Access Compliance Report Public Rights-of-Way (Curb Ramps)

Main Street: UNIVERSITY_AVE Cross Street: HANCEFORD_RD Location: W

ADA ID: RPRK211026135931 Ramp Type: Type 4 - Parallel Initial Pass/Fail: Pass Overall Compliance: No Severity Score: 25

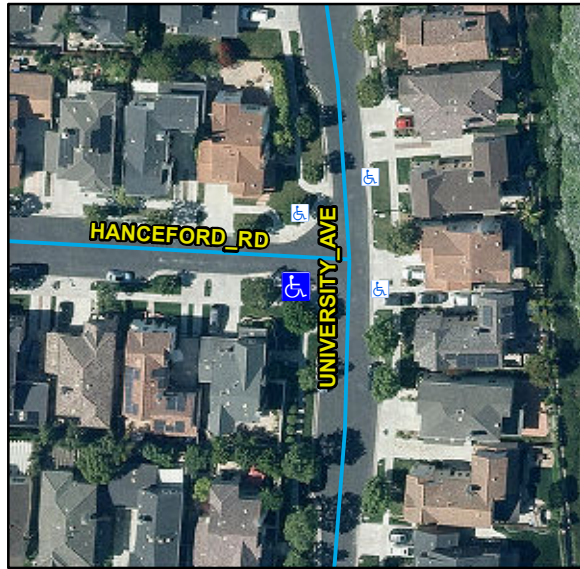
Compliance	Description	Data	Compliance	Description	Data
N/A	Ramp Length LT (in)	132	N/A	Ramp Length RT (in)	140
Yes	Ramp Width LT (in)	53	Yes	Ramp Width RT (in)	53
Yes	Ramp Run Slope LT (%)	4.2	Yes	Ramp Run Slope RT (%)	4.8
Yes	Ramp Cross Slope LT (%)	1.4	Yes	Ramp Cross Slope RT (%)	0.3
N/A	Landing Present	No	No	DWS Provided	No
N/A	Landing Length (in)	N/A	N/A	DWS Contrast	N/A
No	Landing Width (in)	N/A	N/A	DWS Length (in)	N/A
No	Landing Run Slope (%)	N/A	N/A	DWS Full Width	N/A
No	Landing Cross Slope (%)	N/A		DWS Offset Type	N/A
N/A	Landing Movement Obstructed?	No	N/A	DWS Offset Left (in)	N/A
	Landing Movement Type	Curb	N/A	DWS Offset Right (in)	N/A
N/A	Landing Shared	N/A			
N/A	Clear Space	Yes			
N/A	Clear Space To Crosswalk (in)	48			
N/A	Marked Crosswalk 1	No	N/A	Marked Crosswalk 2	No
	Crossing 1 Direction	SE		Crossing 2 Direction	NE
N/A	Marked Crosswalk 1 Width (in)	N/A		Marked Crosswalk 2 Width (in)	N/A

N/A	Ramp Inside Crosswalk 1	N/A	N/A	Ramp Inside Crosswalk 2	N/A
	Crossing 1 Slope (%)	2.2		Crossing 2 Slope (%)	2
	Crossing 1 Cross Slope (%)	0.7		Crossing 2 Cross Slope (%)	0.6
Yes	Gutter Ponding	No	Yes	Curb Slope	3.6
Yes	Gutter Lip Height (in)	0		Road Run Slope (%)	2.5
No	Gutter Run Slope (%)	11.7		Road Cross Slope (%)	0.6
Yes	Gutter Cross Slope (%)	0.3	No	Perpendicular Joint Present	No
Yes	Overall Surface Condition	Acceptable			
	Cross Gutter Present?	No		Spandrel Present?	No
	Replace Cross Gutter?	N/A		Replace Spandrel?	N/A

Remove & Replace Curb Ramp With Two New Directional Ramps or Equivalent. Remove & Replace Gutter.
